BROADVIEW ACCESS MANAGEMENT REVIEW

US 211/US17/29 BUS (BROADVIEW AVENUE), WARRENTON, VA

Date:	August 27, 2018	Project #: 21905
To:	Brandie Schaeffer, Town of Warrenton	
From:	Chris Tiesler, PE; Bradley Reynolds, PE; and Andy Butsick, PE

Exhibit 3. Warrant 2 (Four-Hour Vehicular Volume) – Broadview Avenue/Gold Cup Drive

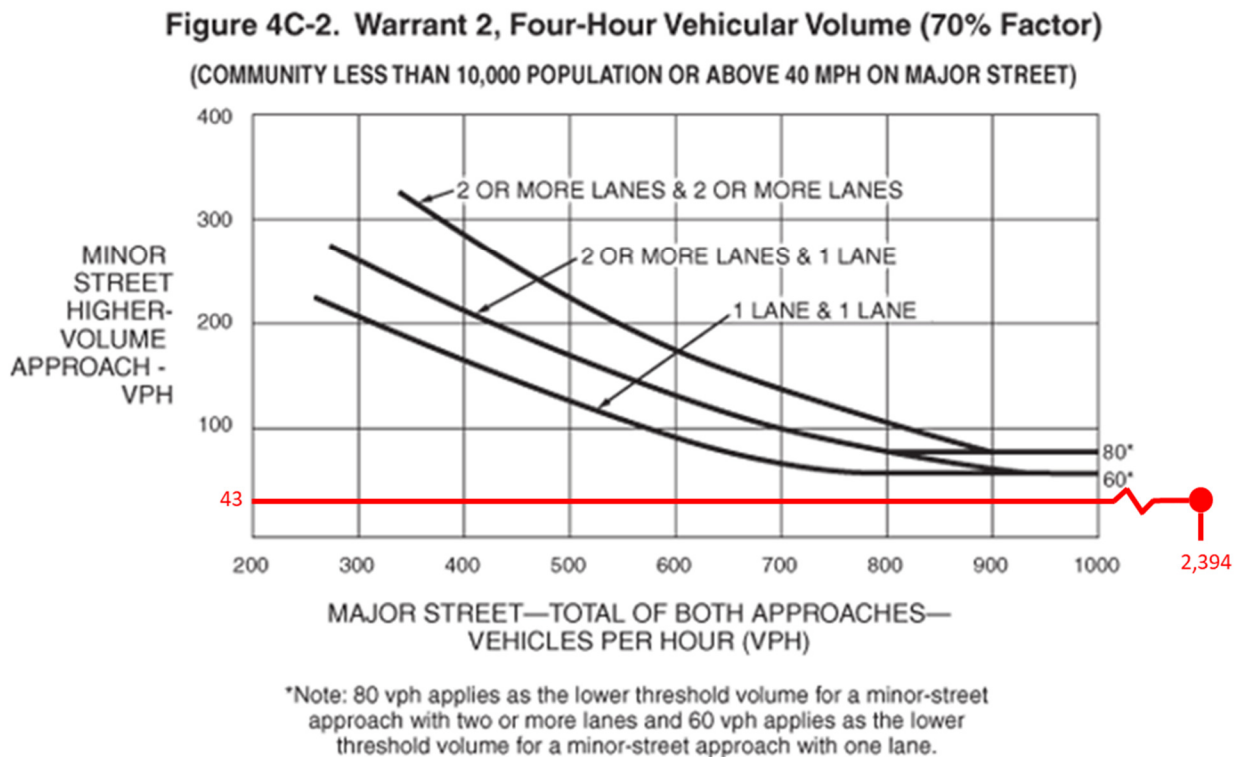
As shown in **Exhibit 3**, the 4th highest hour volumes do not exceed the minimum thresholds and do not warrant a traffic signal.

Exhibit 4. Warrant 3 (Peak Hour Volume Volume) – Broadview Avenue/Gold Cup Drive

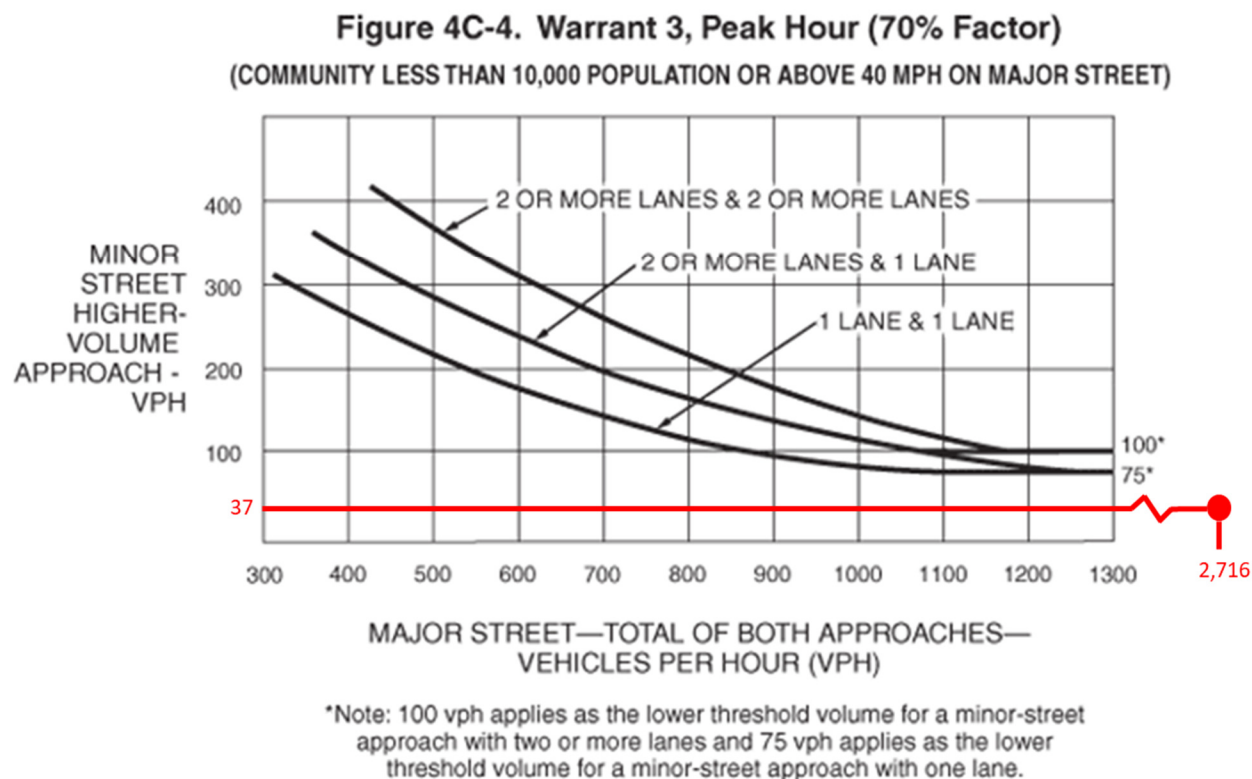
As shown in **Exhibit 4**, peak hour volumes do not exceed the minimum thresholds for an intersection with a one-lane minor street and do not warrant a traffic signal.

FIGURE 1A

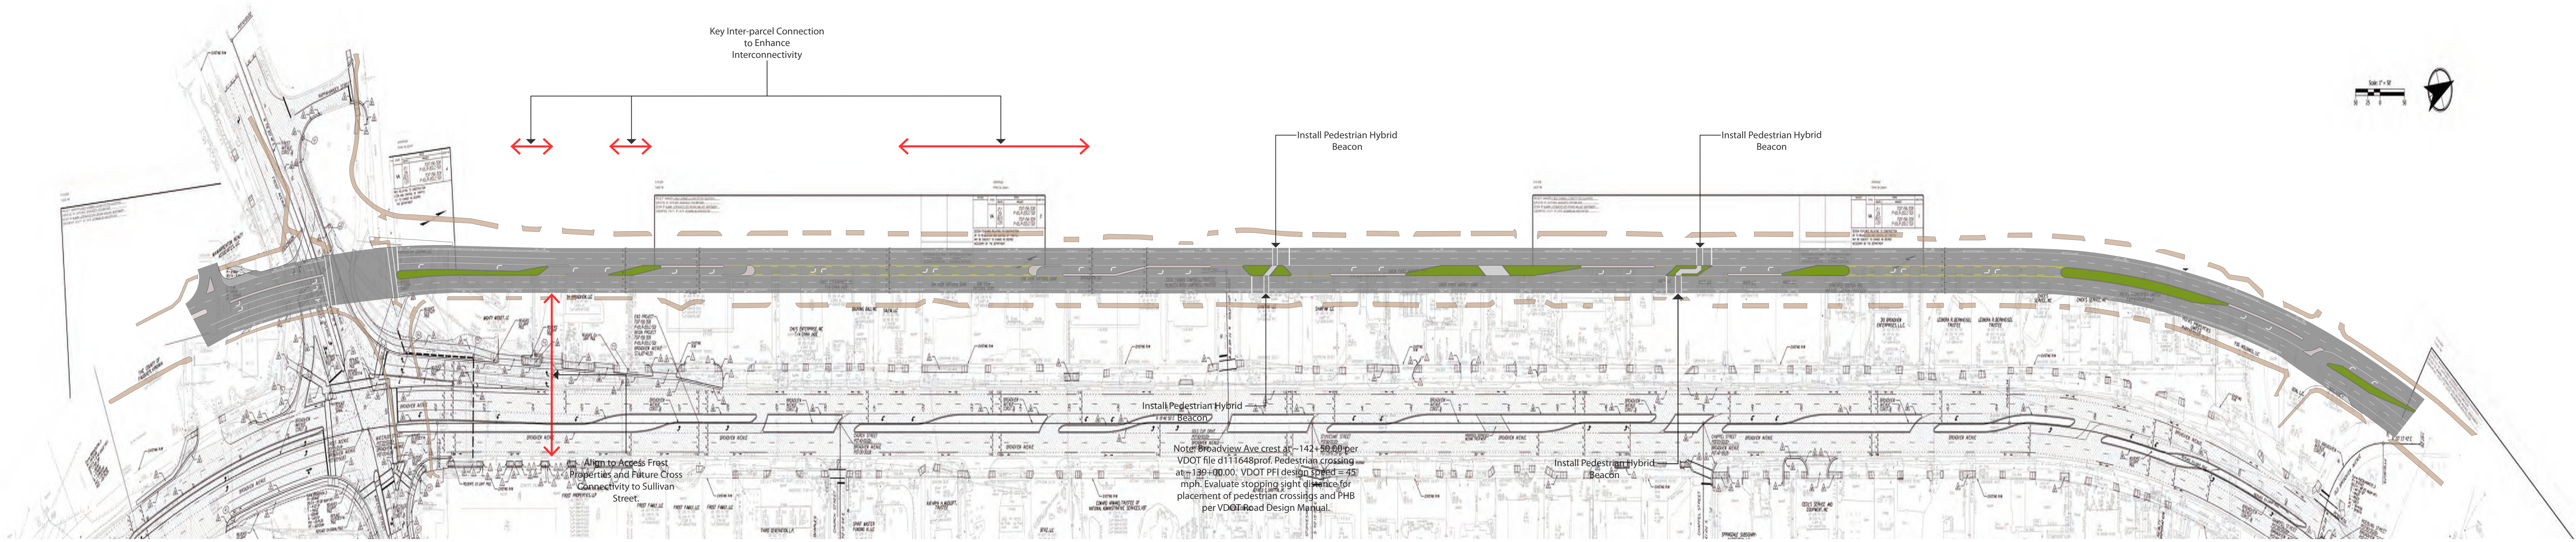
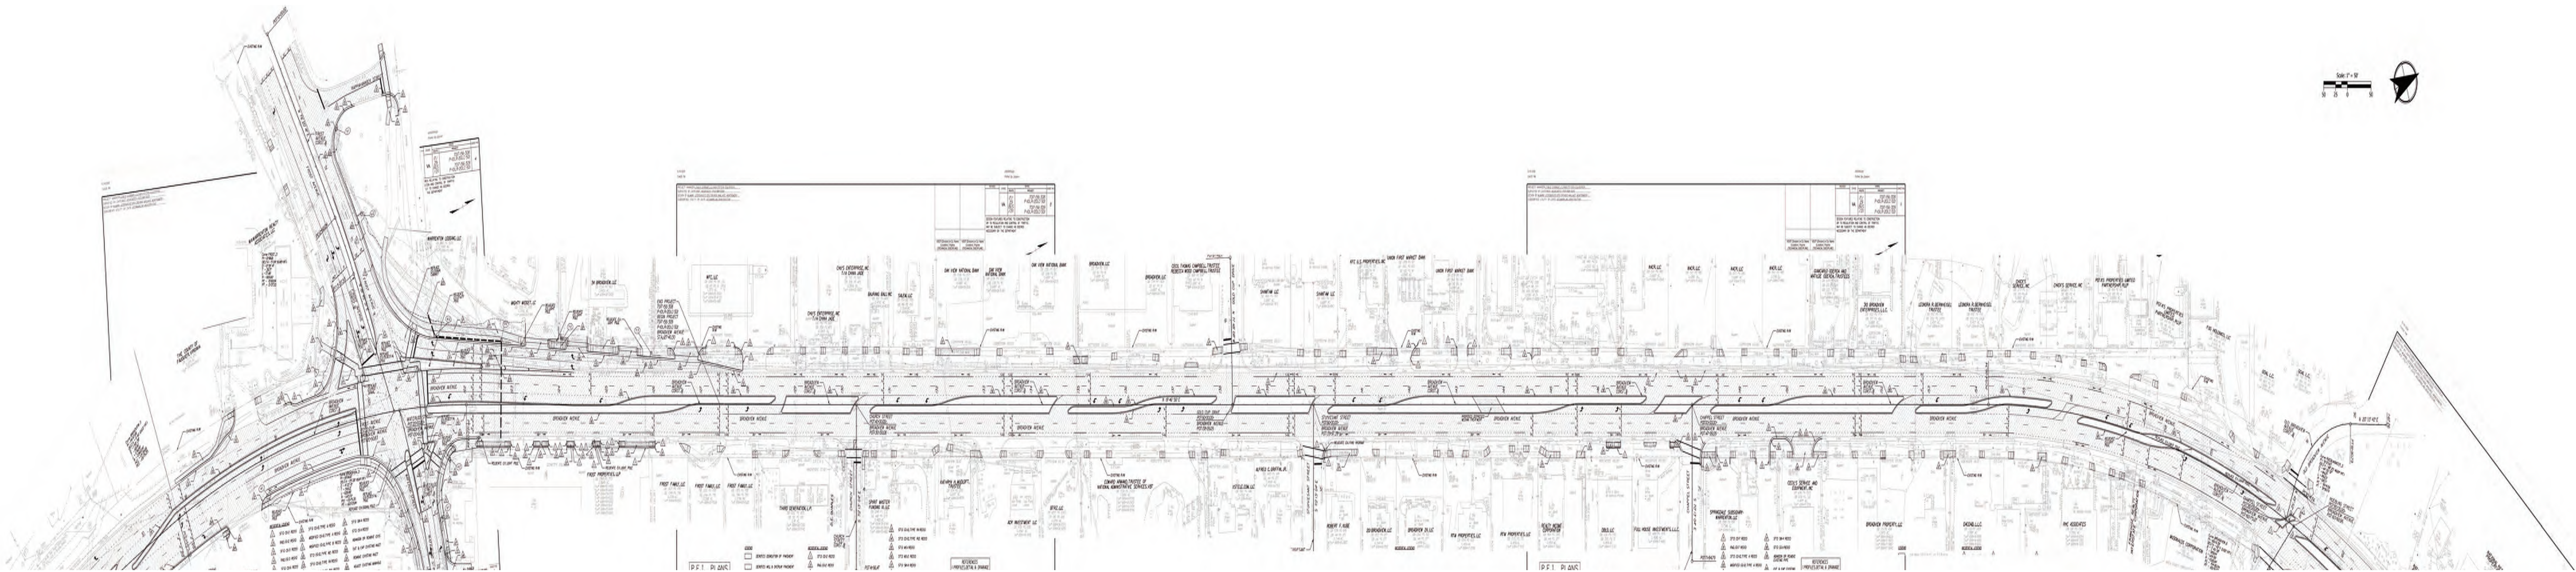
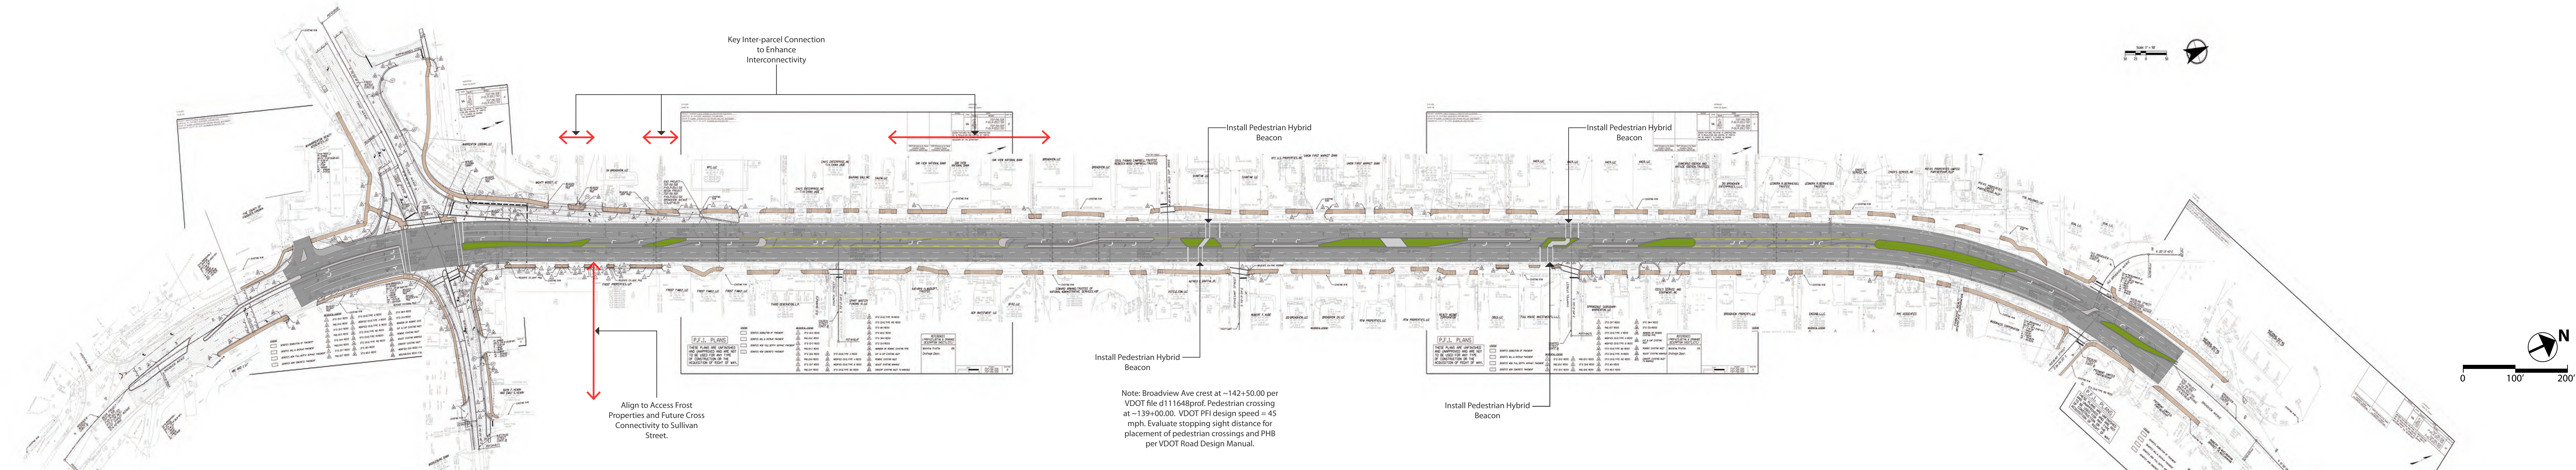
In **Appendix A, Figure 1A** comparatively illustrates three (3) concepts: 1) Town of Warrenton's preferred concept, 2) VDOT's 30% PFI Plan (dated May 14th, 2018), and 3) VDOT's previous

recommended geometric improvements concept per the ADA/Access Management/Traffic Assessment Report, VDOT, April 2015, by Wallace Montgomery. **Figure 1B** illustrates the Town of Warrenton's preferred concept.

In consultation with the Town of Warrenton's decision makers and staff, Kittelson has prepared an access management concept plan reflective of the Town of Warrenton's preferred concept that modifies VDOT's plan to provide a four-lane facility with landscape medians and center two-way left-turn lanes (CTWLTL) and buffered bike lanes along the Broadview Avenue corridor. This conceptual plan attempts to incorporate developed design studies and established project goals, as detailed in the ADA/Access Management/Traffic Assessment Report, VDOT, April 2015, along with the Town of Warrenton's vision for the corridor and complete street initiatives by implementing the following:

- Installation of medians and center two-way left-turn lanes – A total of approximately 8 median breaks/CTWLTL segments within the Broadview Avenue study corridor, a similar number of median breaks proposed in the *Broadview Access Management Study, VDOT, February 2013*.

FIGURE 1B

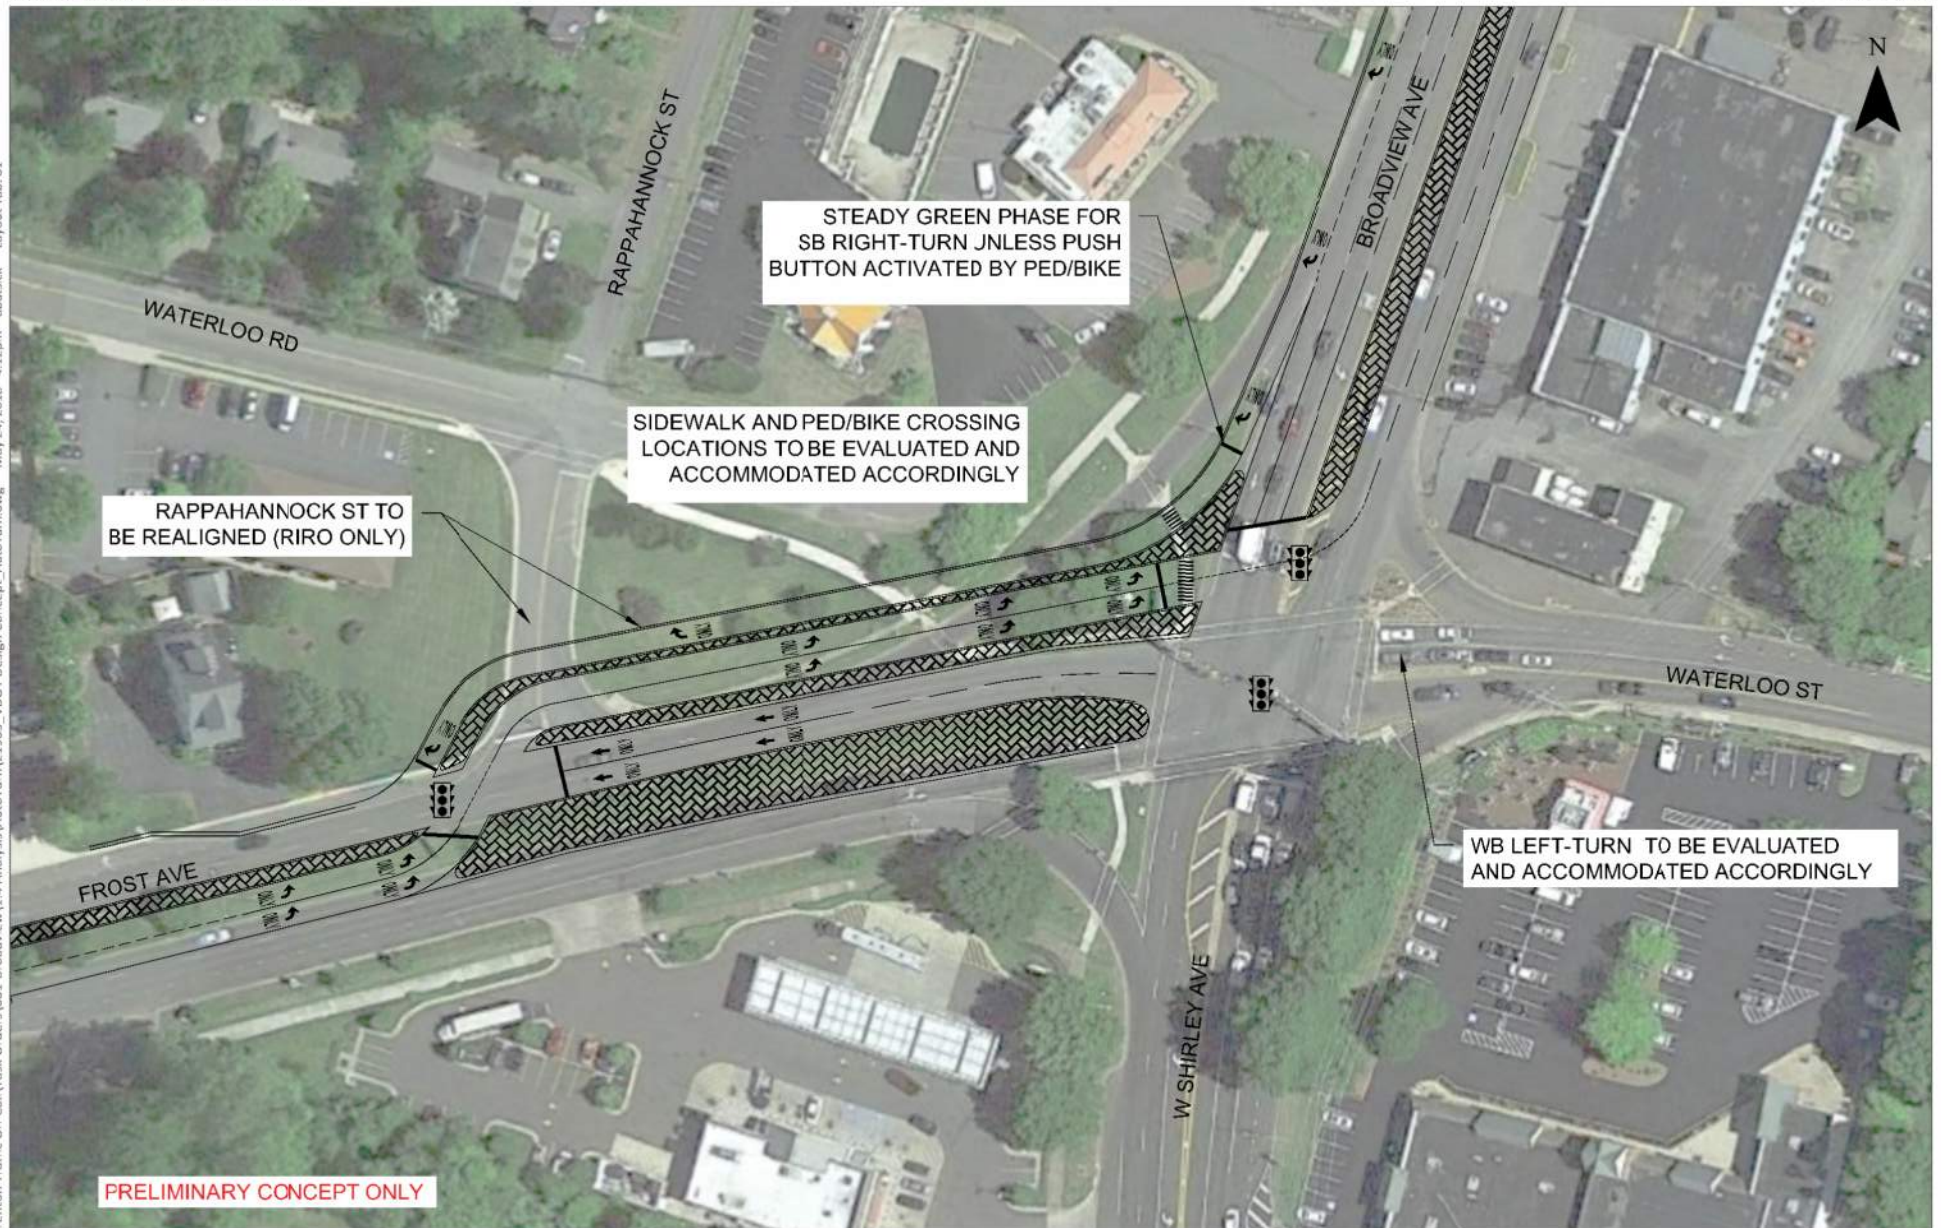
In consultation with the Town of Warrenton's decision makers and staff, the Town's preferred intersection design is consistent with VDOT's recommended Alternative 2 geometric improvements to provide more safety for pedestrians and access along westbound Frost Avenue while improving operations at the study intersection, with minor access break modifications. In **Appendix A, Figures 1A**

and 1B illustrate the Town's preferred concept at Broadview Avenue at Frost Avenue. Intersection improvements to mitigate operational deficiencies include (proposed geometric modifications in **bold**):

- Provide signalized southbound dual right-turn lanes on Broadview Avenue.
- Provide signalized northbound dual left-turn lanes on Shirley Avenue.
- Provide pedestrian accommodations based on modified geometry.
- Install median on Broadview Avenue. Provide first median break approximately **400 feet north of intersection for southbound left-turns/U-turns to access Frost properties.**
- Install median on Shirley Avenue. Provide first median break approximately 250 feet south of intersection **for left-in/right-in/right-out access to Wawa. Install driveway island at Wawa to restrict left-out movement.**
